Subject: Responses to NRC Request for Additional Information (RAI) on
ComEd Licensing Topical Report NFSR-0111
BWR Transient Analysis Methods for:
LaSalle County Nuclear Power Station Units 1 and 2,
Dresden Nuclear Power Station Units 2 and 3, and
Quad Cities Nuclear Power Station Units 1 and 2
NRC Docket Nos. 50-373/374, 50-237/249, and 50-254/265

RESPONSES TO 4/4/96 NRC REQUEST FOR ADDITIONAL
INFORMATION ON
ComEd Licensing Topical Report NFSR-0111

Figure 1 LaSalle BWR/5 RWLSC Core Power

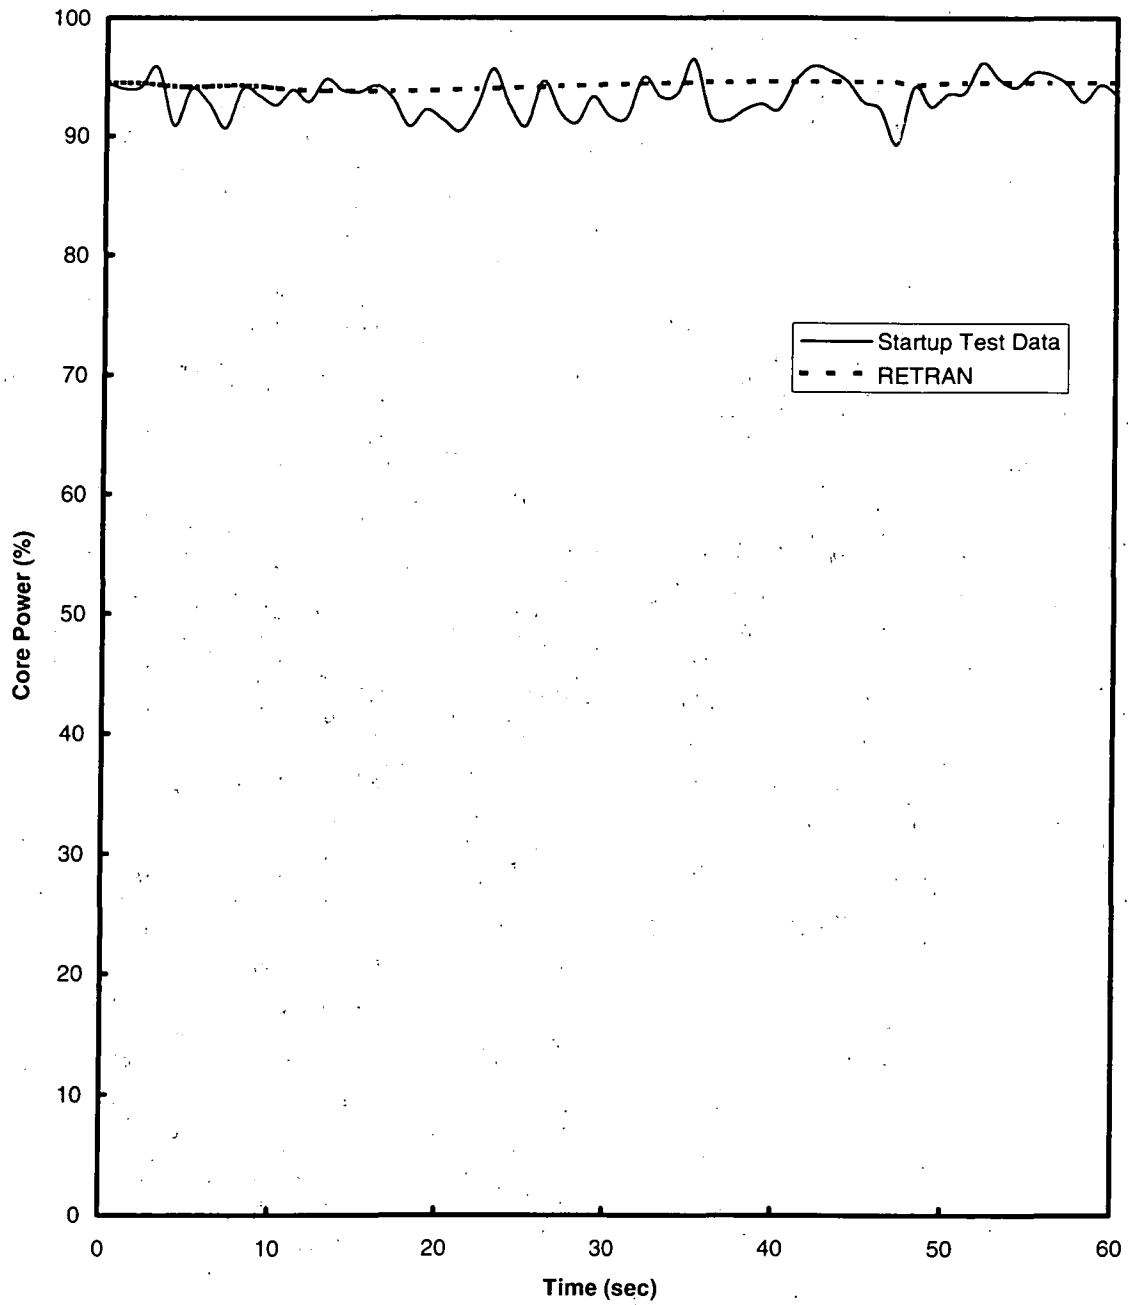
In your topical report dated June 1995 for the LaSalle Reactor Water Level Setpoint Change (RWLSC), you state that core power, steam flow rate, and reactor pressure remain relatively constant as expected over the course of the transient (page 4-5). Provide those results and compare them to the test data, if available.

The negative 5 inch reactor water level setpoint change is a mild event which results in small changes to the reactor power, reactor pressure and steam flow rate. Figure 1 shows the comparison to the Average Power Range Monitor (APRM) channel for core power. The data shows acceptable agreement. Figure 2 shows the comparison of the reactor dome pressure response to the reactor water level setpoint change. The results show acceptable agreement. Both the startup test data and the RETRAN02 results show less than 2% variation over the duration of the reactor water level setpoint change event. Figure 3 shows the steam flow comparison for this event. The RETRAN02 results show acceptable agreement to the startup test data. Again both the startup test data and the RETRAN02 results show less than 2% variation over the period of interest for a RWLSC event. Since dome pressure and steam flow vary by less than 2%, the statement that these variables remain relatively constant is acceptable.

Figure 4 LaSalle BWR/5 Pressure Regulator "A" Sensed Pressure

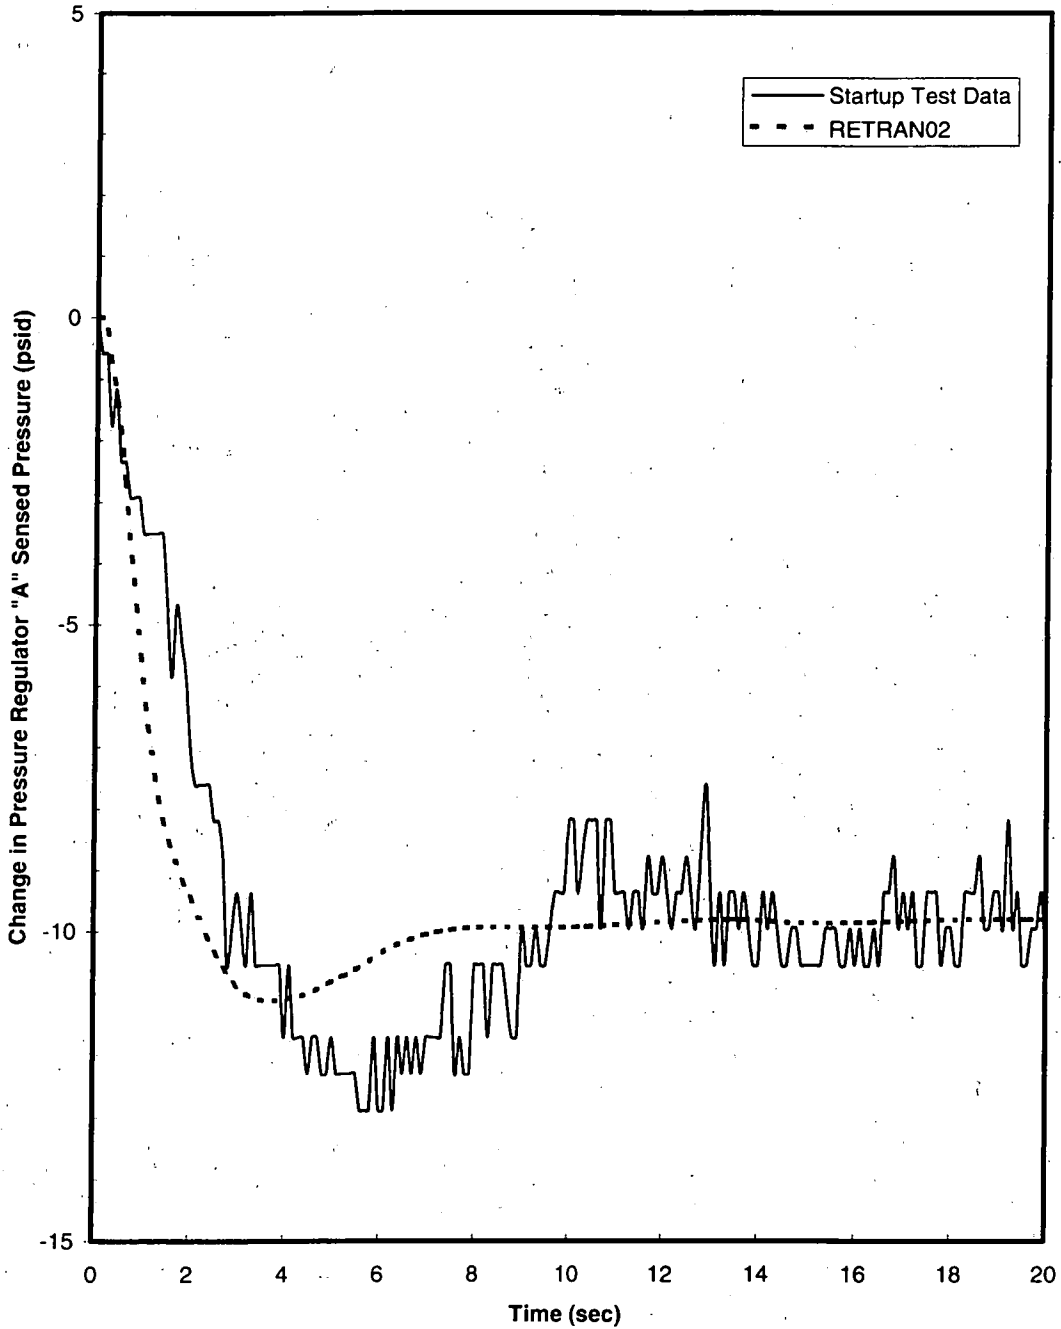
From the several tests/benchmarks presented in the report, pressure discrepancies between the test data and RETRAN02 results could be observed throughout. For example, for the LaSalle Pressure Regulator Setpoint Change (PRSC), test data stabilized 1.5 psi higher than the RETRAN02 results; for the Dual Recirculation Pump Trip (DRPT), a 3 psi difference is observed; for the Main Steam Isolation Valve Closure (MSIVC), the test data stabilized 8 psi lower than the RETRAN02 results; and for the Peach Bottom turbine trip test 2, the reactor dome pressure shows a 3 psi difference.

Considering that most of the other parameters plotted show superior agreement, discuss why these pressure differences are observed. Where is the pressure parameter measured (both for the test data and in the RETRAN02 model)?

Dome pressure differences in the LaSalle PRSC from Figure 4.2-5 of the LTR were investigated. The pressure regulator pressure which is measured at the turbine inlet provides a good match between RETRAN02 results and measured data as shown in Figure 4. There is a discrepancy between the dome pressures, which indicates that the steamline pressure drop changed during the startup test. There are three possible contributions for the startup test data reflecting a change in the steamline pressure drop: first, if the steam flow rate changed significantly from the initial condition (time = 0 seconds) to the final condition (time = 20 seconds); second, if the steam quality changed significantly from the initial condition to the final condition; and third, the pressure instrumentation characteristics may limit the accurate prediction of small pressure changes.
